SUBMITTAL IDENTIFICATION SHEET

WEBSTER UNIVERSITY ISB
PROJECT NAME

055213-014
CONTRACTOR / CM SUBMITTAL NO.

055213
SPECIFICATION SECTION / PARAGRAPH

LOADING DOCK~ PLAN VIEW

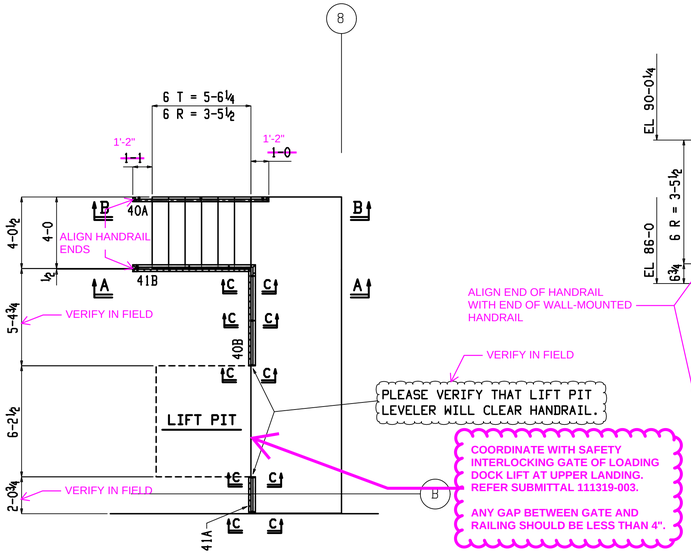
PLEASE VERIFY THAT LIFT PIT LEVELER WILL CLEAR HANDRAIL.

COORDINATE WITH SAFETY INTERLOCKING GATE OF LOADING DOCK LIFT AT UPPER LANDING. REFER SUBMITTAL 111319-003.

ANY GAP BETWEEN GATE AND RAILING SHOULD BE LESS THAN 4".

VERIFY IN FIELD
